CALIFORNIA COASTAL COMMISSION

APPEAL STAFF REPORT DE NOVO HEARING

Appeal number A-3-SCO-98-101, Bailey/Steltenpohl Mixed Use Davenport Project

Project description Reconstruct a 13,127 square foot building and add 9,791 square feet in three phases to create a 22,918 gross square foot mixed-use building (commercial, residential, and manufacturing); construct a 750 square foot greenhouse; convert an existing boat into a residential structure; and construct a 66 space recessed parking lot (involves grading to depress below existing grade).

UPPER PARKING LOT
BUILDING ENVELOPE

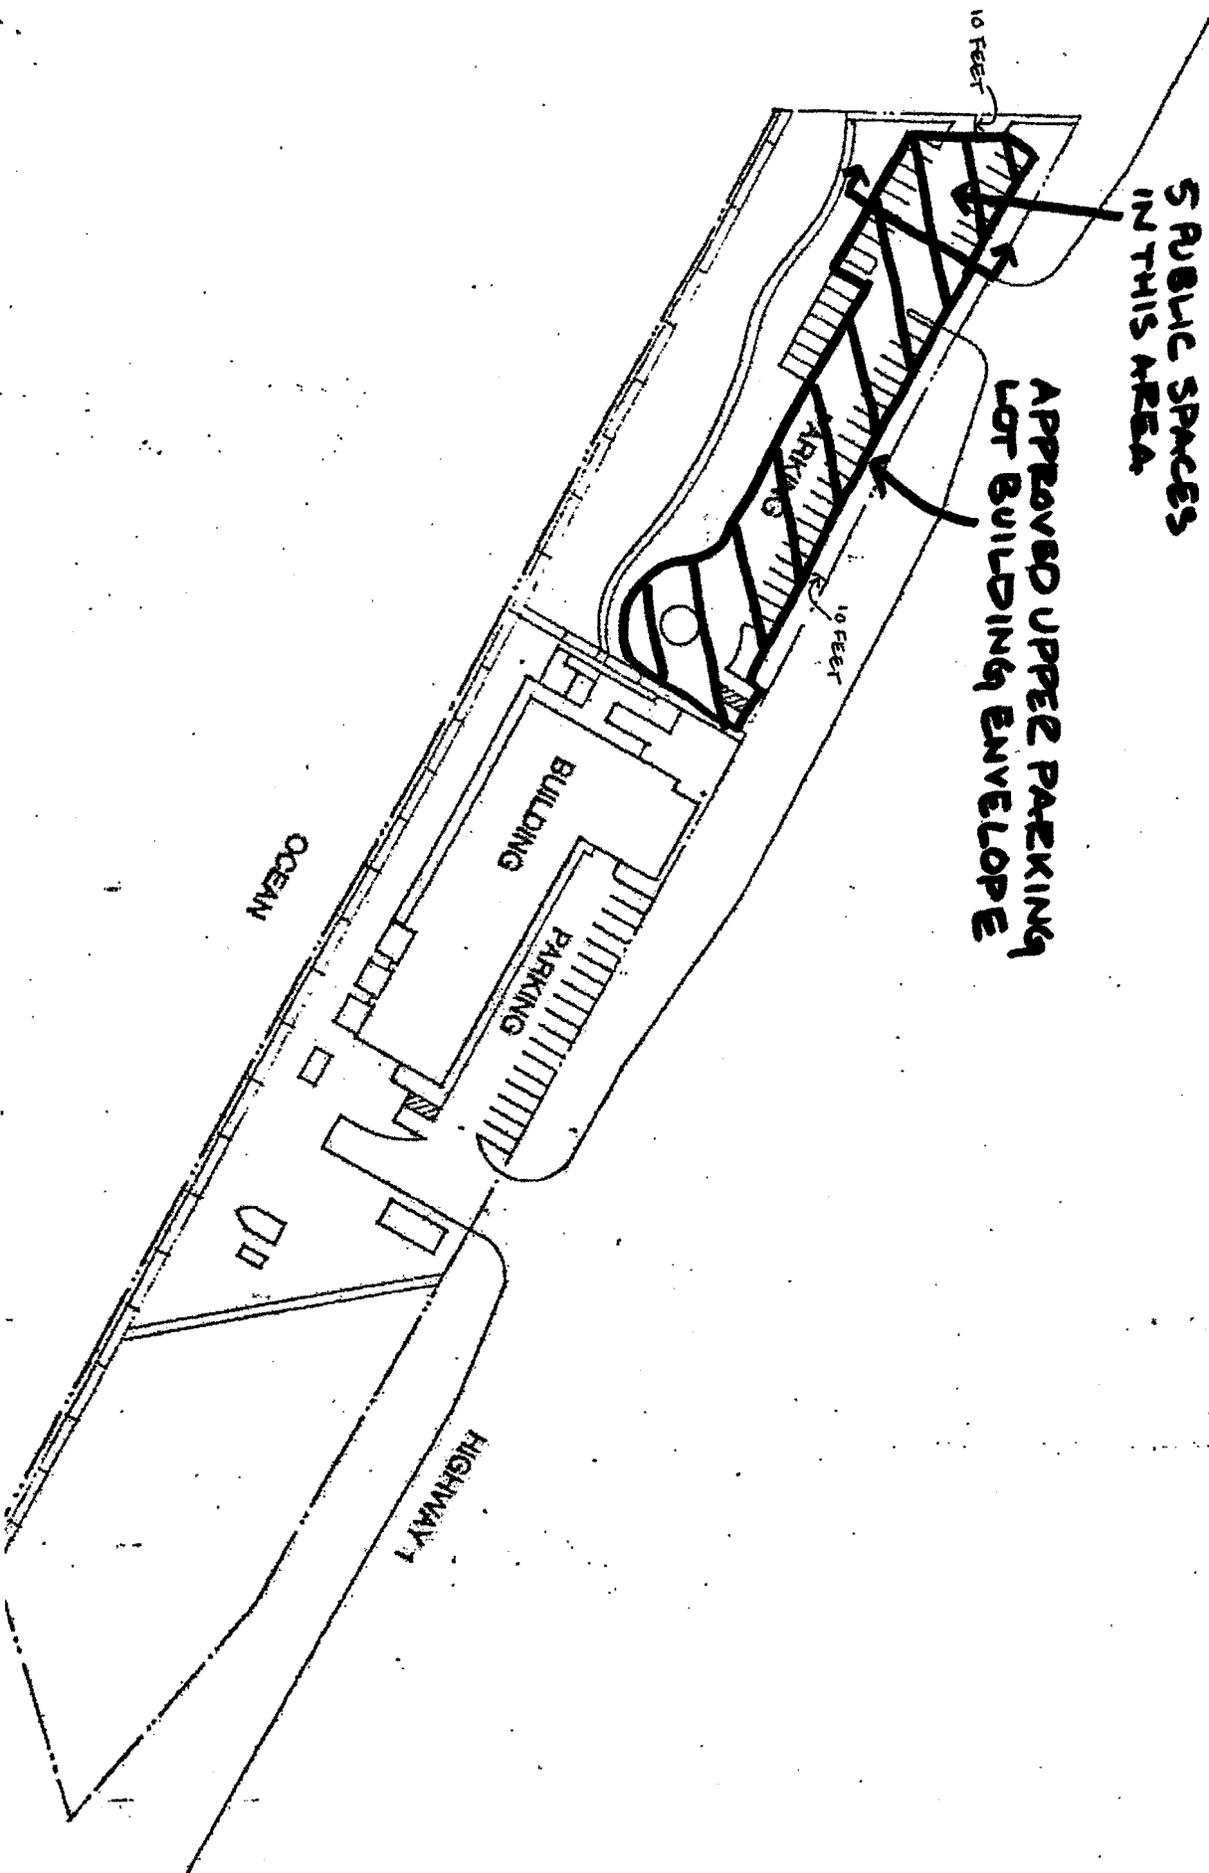
As conditioned, the Highway One view corridor, the blufftop's open space character, and Davenport's rustic, small-scale community character are all maintained with the modified and reduced in scale upper parking lot area. Such a parking lot would be compatible with this scenic location to the maximum extent possible while still accommodating a visitor serving mixed use facility at the site. Only as conditioned can the proposed upper parking lot area be found consistent with the small scale and special community LCP polices cited above.

7. Plans shall provide that busses and large trucks may only park and/or discharge passengers in the lower (southeast) parking lot.
8. Not more than 36 total parking spaces shall be provided in the upper parking lot, and not more than 20 total parking spaces shall be provided in the lower parking lot, for a total of not more than 56 parking spaces on the Approved Project site. If the Permittee demonstrates to the satisfaction of the Executive Director of the Coastal Commission that more than 56 spaces can be accommodated on the Approved Project site within the combined area consisting of the upper parking lot building envelope (see Exhibit G) and the proposed lower parking lot pavement area (see page 2 of Exhibit D), and consistent with all other parking parameters established in this condition, said spaces shall be allowed provided that they are made available to the general public from the hours of 5 a.m. to 10 p.m..
